MAY 16 2008
Columbia River Crossing

From: NoEmailProvided@columbiarivercrossing.org
To: [Columbia River Crossing;](#)
CC:
Subject: Comment from CRC DraftEIS Comments Page
Date: Tuesday, May 27, 2008 2:29:13 PM
Attachments:

Columbia River **CROSSING** Draft Environmental Impact Statement **Comment Form**

(MY FAVORITE CHOICE)

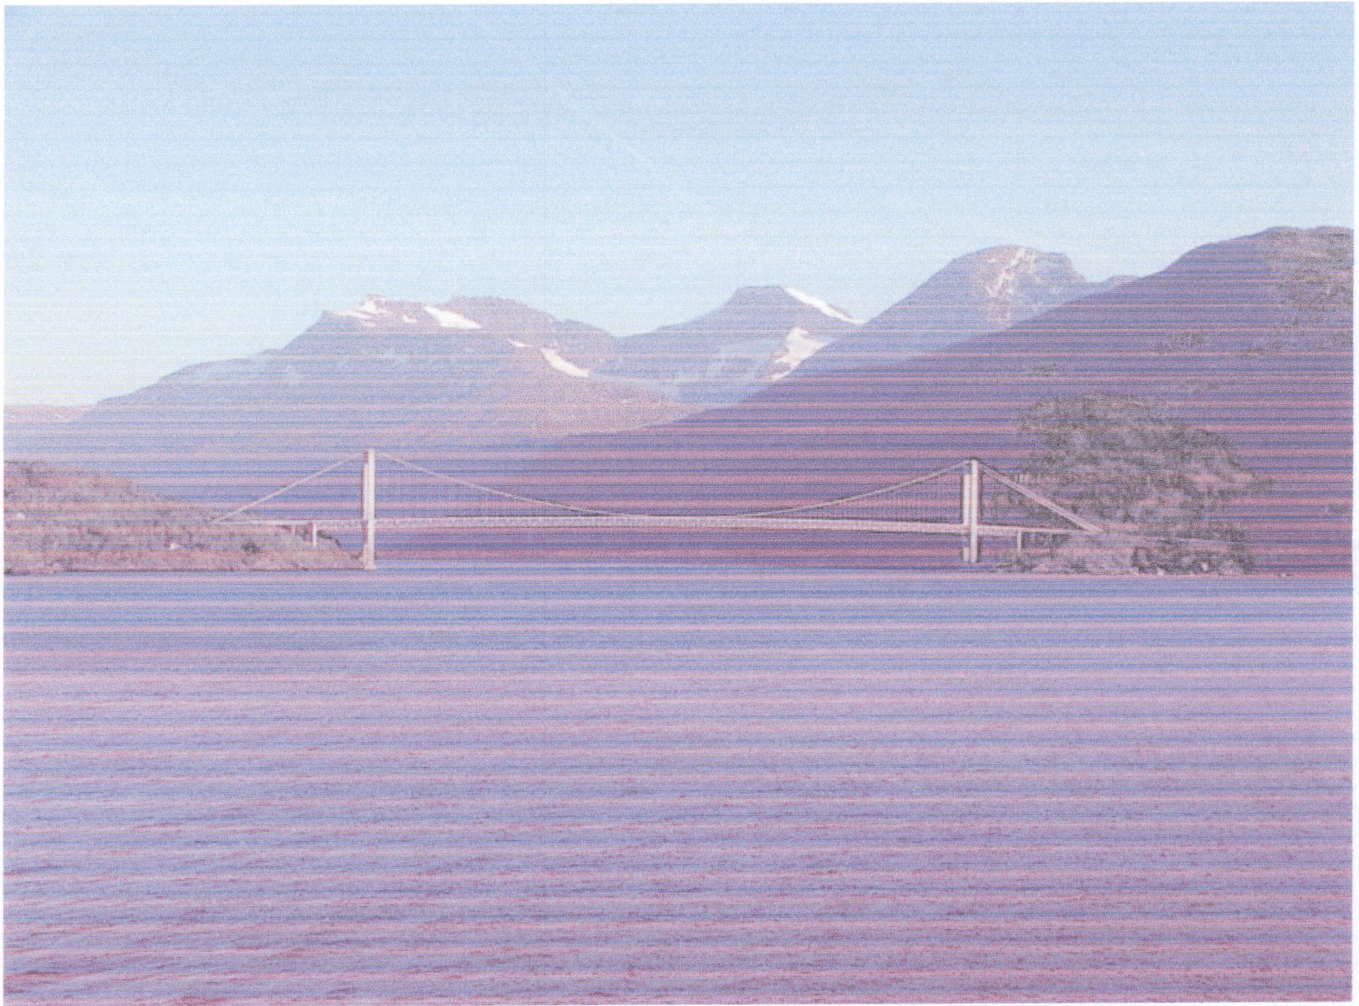
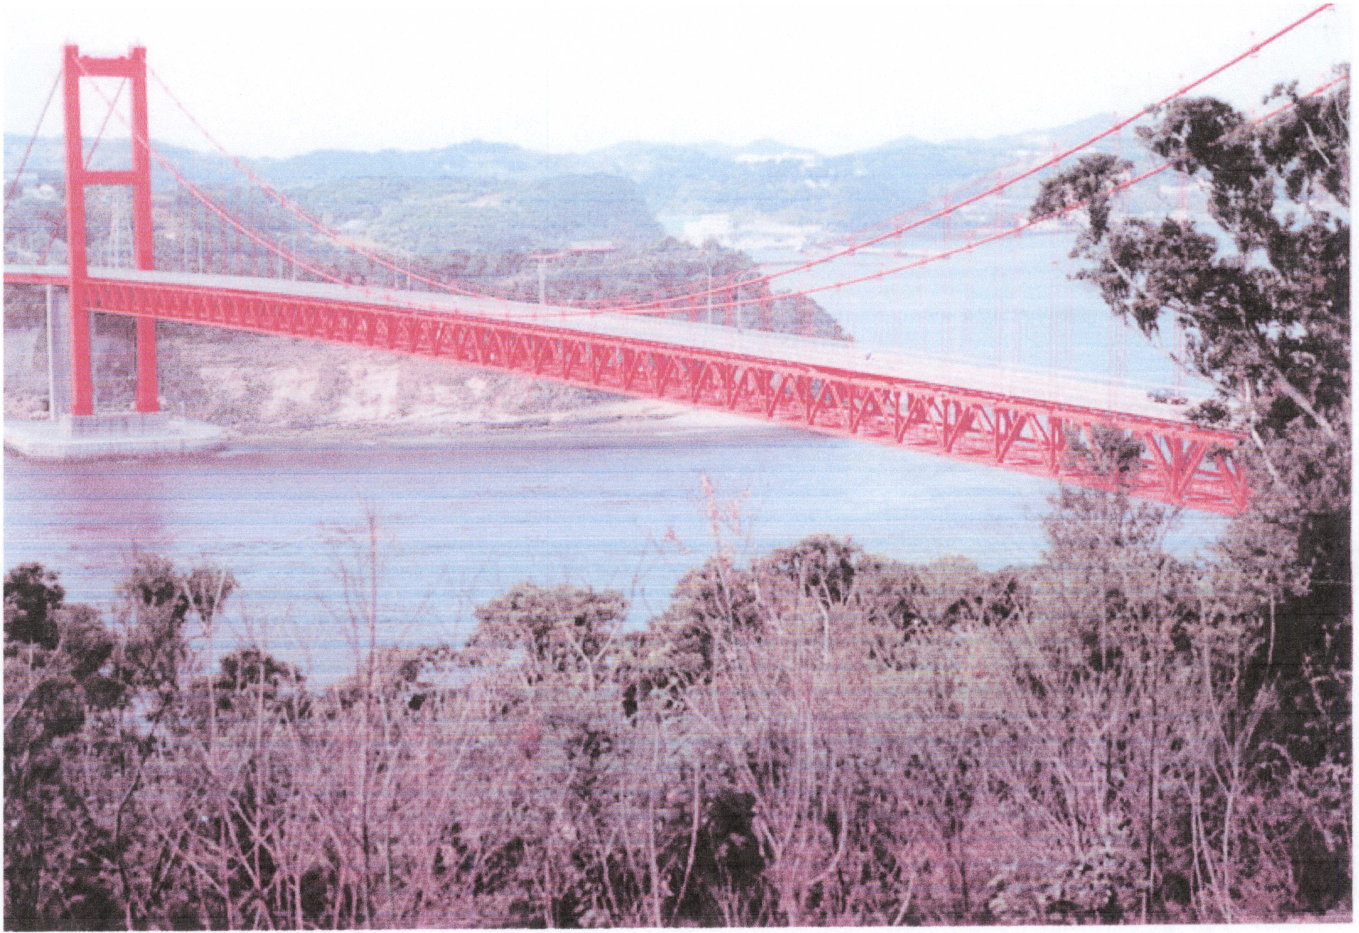
We should spend Many more Millions and make the New Bridge a Modern, Unique and Beautiful Bridge. Not a concrete Bridge like I-205.

USE ONE OLD BRIDGES FOOTINGS & LEGS
FOR MODERN ARCHED CONCRETE TRAIN
BRIDGE ~~AD~~ NEXT TO NEW BRIDGE
RESEMBLING OR SIMILAR TO NEW BRIDGE
TYING IT IN. -

OR DESIGN RAIL & PED as part of the
structure.

PBAC Proposed Pedestrian and Bicycle System for Replacement Bridge

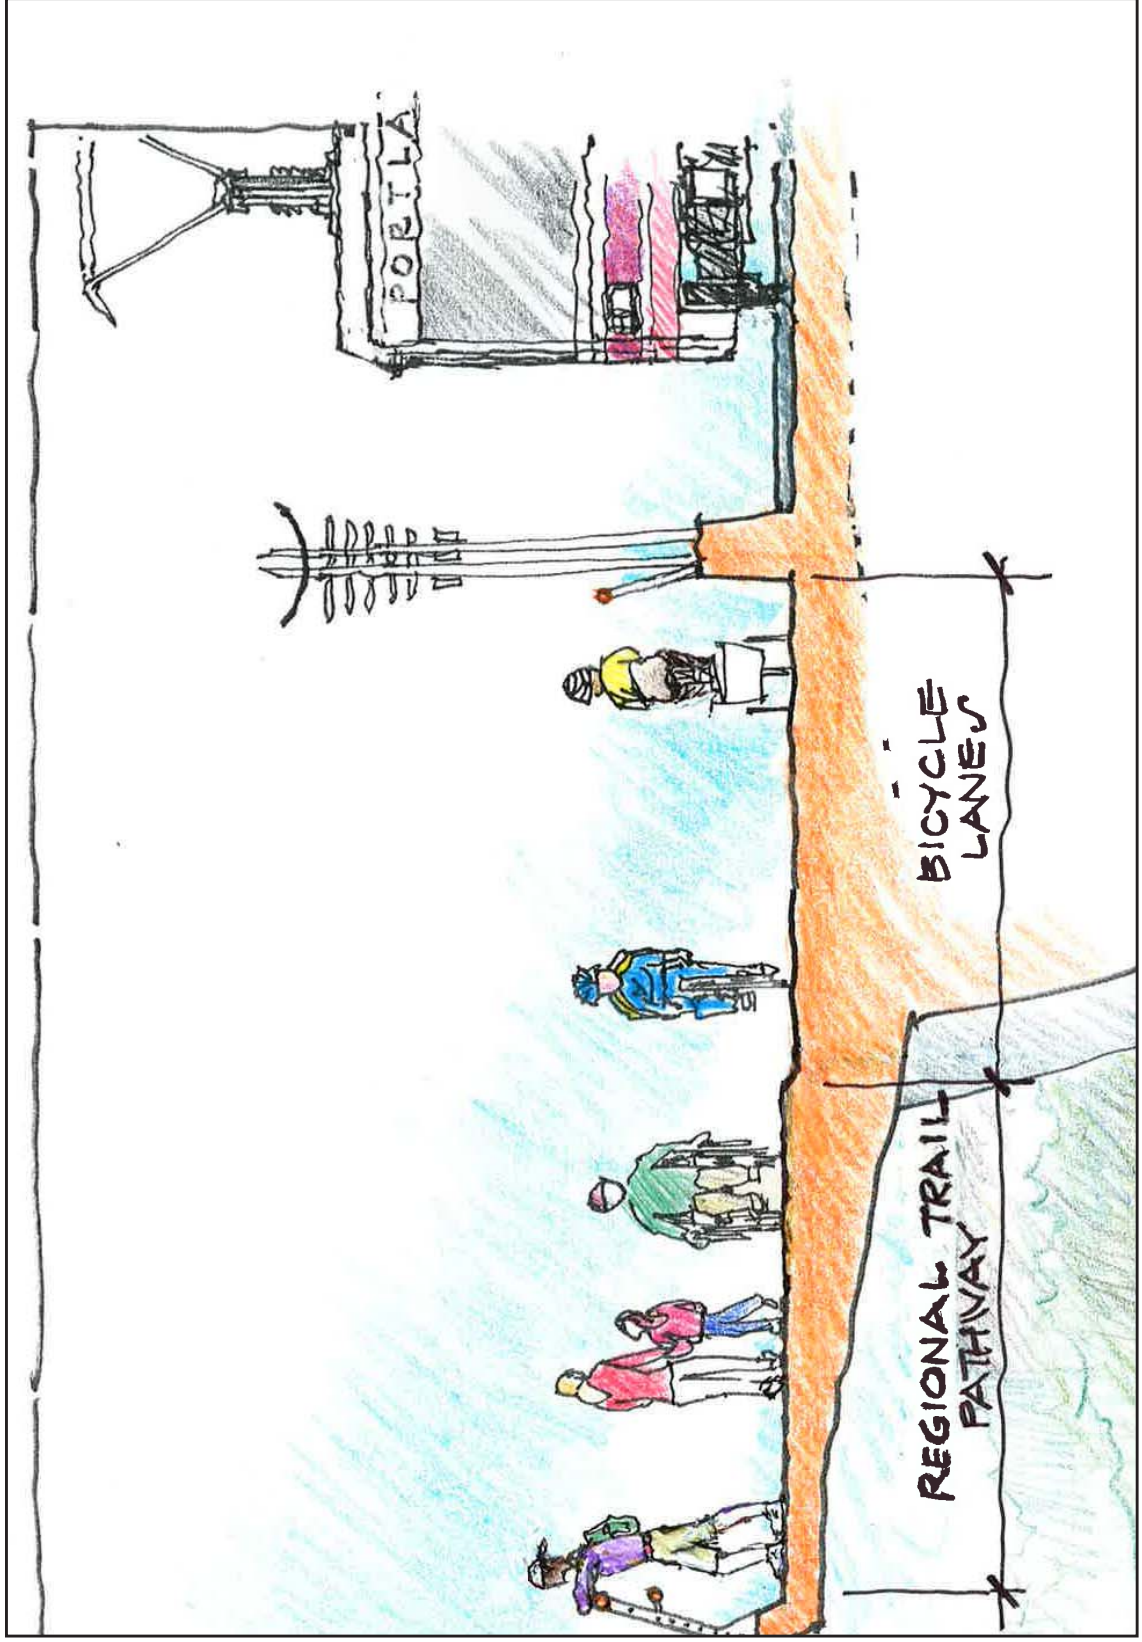
- The overall pathway on the western bridge (adjacent to the transit guideway) must provide separation between recreational users and higher speed bicycle users. To provide this separation, a 12-foot wide regional trail should be provided adjacent to, and to the west of, a pair of six-foot wide bicycle lanes (see attached rendering). These recommended widths are exclusive of potentially needed shy distances, i.e., free and clear of poles and other obstructions to enable safe pedestrian and bicycle movement (a summary of agency standards for multiuse paths, sidewalks and bike lanes is attached).
